ADDENDUM NO. 1
TO
PROCUREMENT AND CONTRACTING REQUIREMENTS
FOR
NineStar CR200 Sewer – Division I
FOR
NINESTAR CONNECT
Issue Date: October 25th, 2023

The following, as additions to and modifications in the Bidding Requirements and Contract Documents, will be included in, and become a part of the **NineStar CR200 Sewer – Division I**. This Addendum forms a part of the Contract Documents. Bidders are, therefore, instructed to take the following into account in rendering any Bid for this work. Acknowledge receipt of this Addendum in the space provided on the Bid Form.

E600

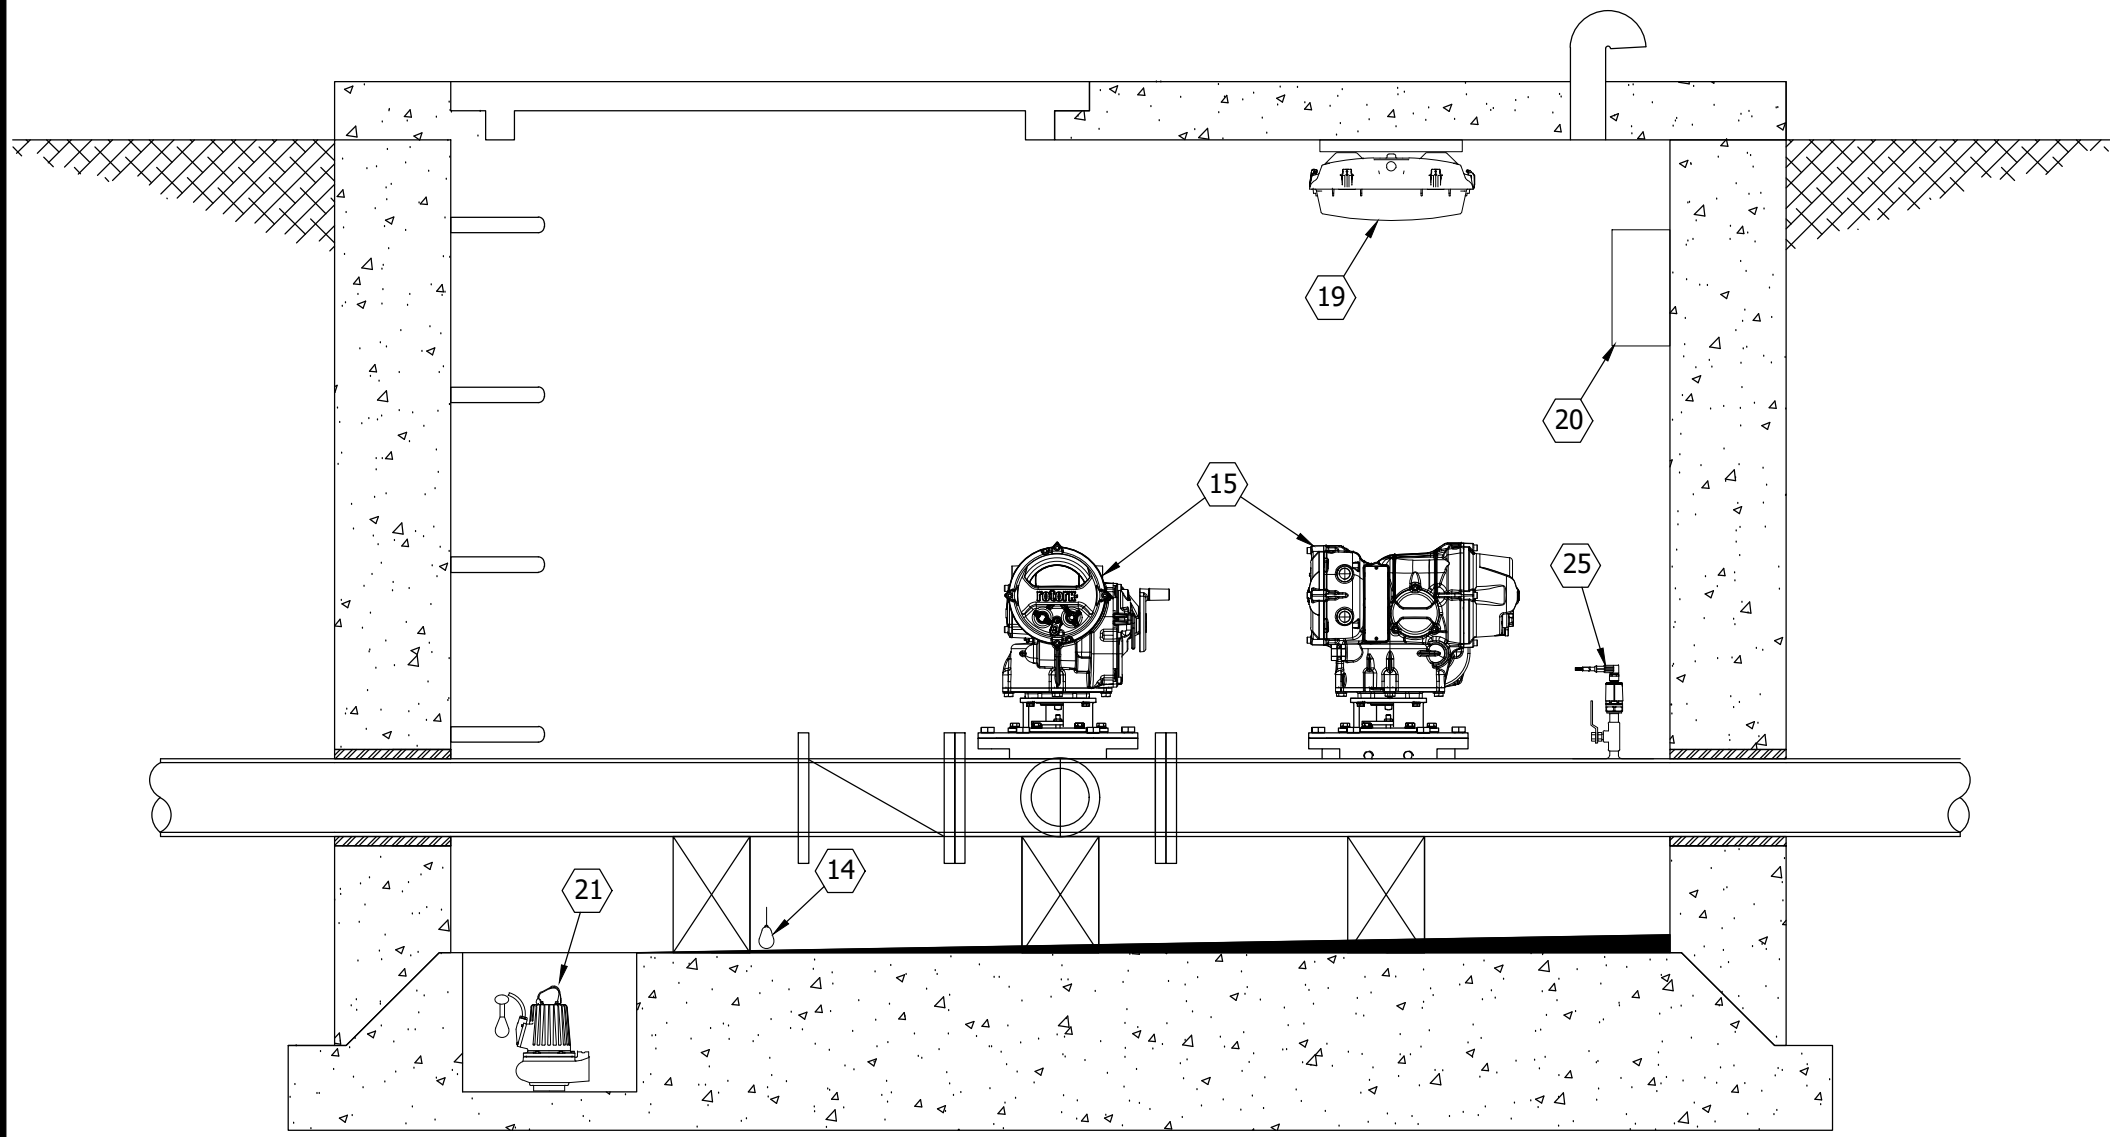
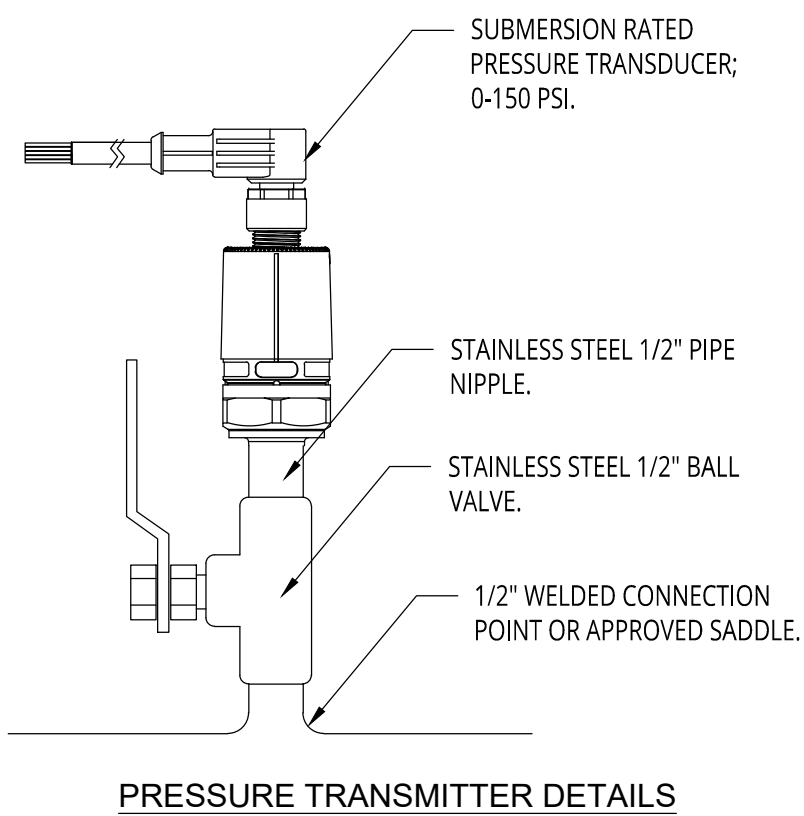
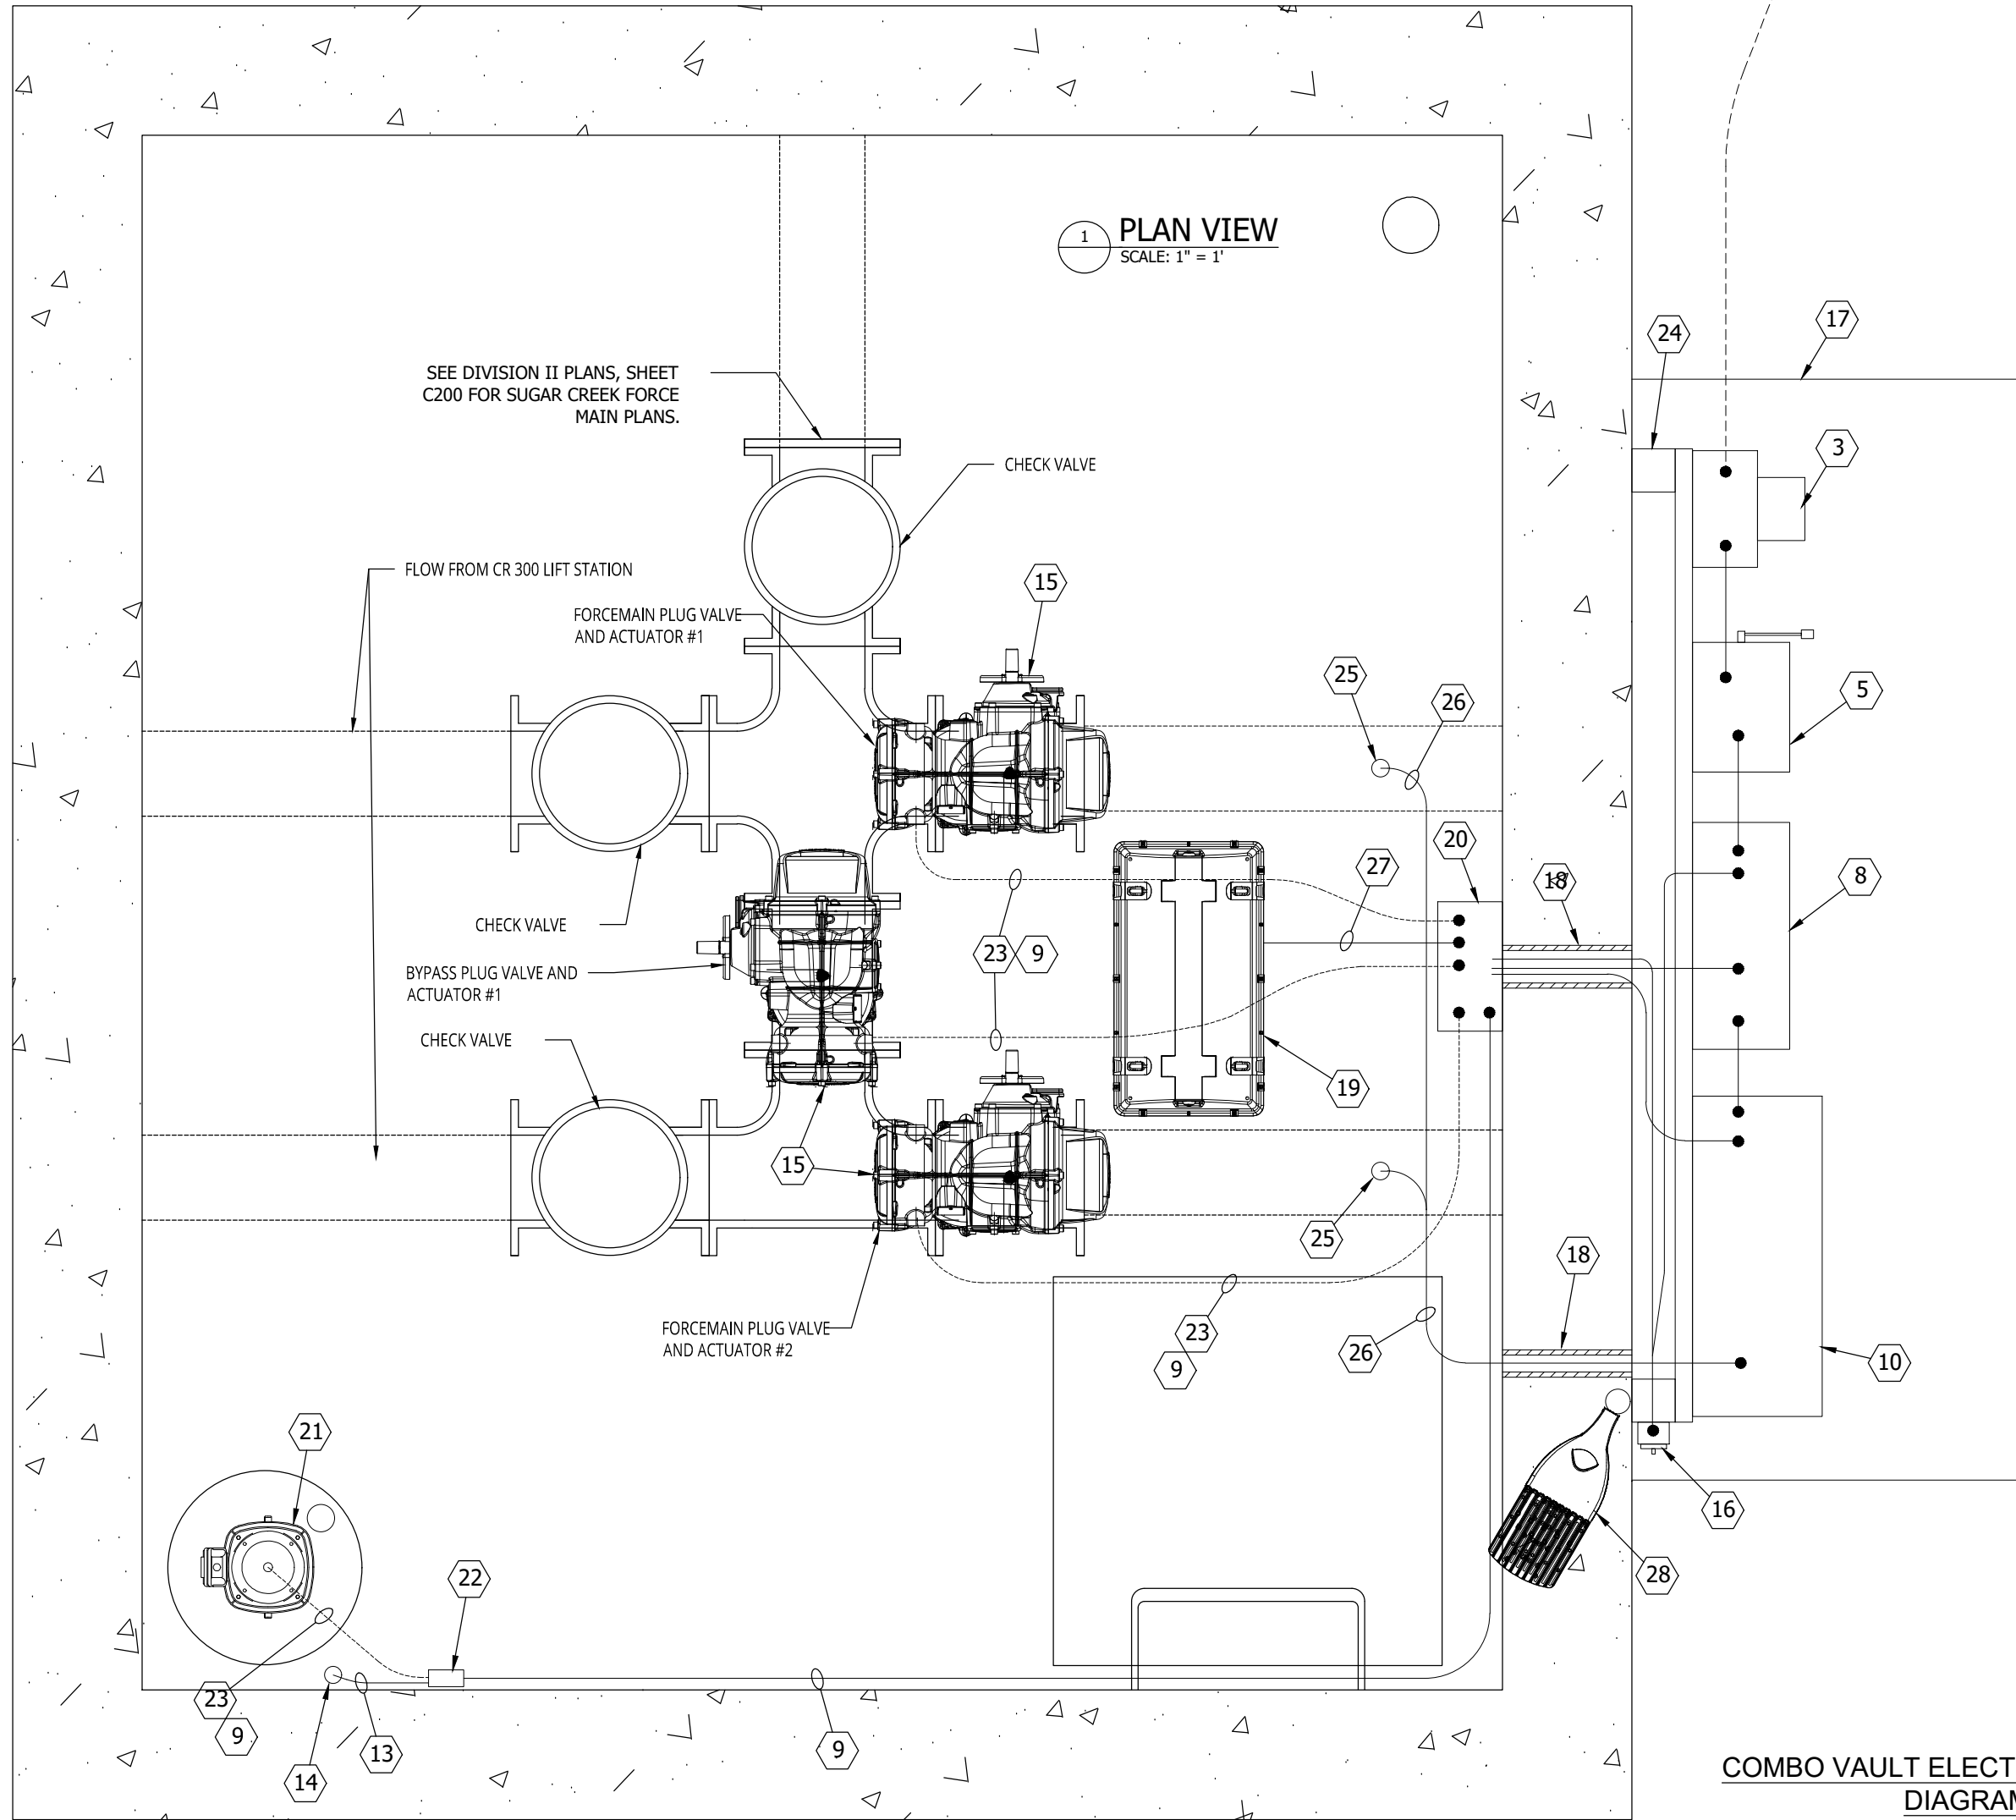
- y. Sheet E500 – Overall Network Architecture (Added information about Valve Control Vault PLC to network overview.)
- z. Sheet E600-E603 –Valve Control Vault Sheets (Updated Sheet Numbers to be in separate electrical division. Previously sheets E140-E143.)
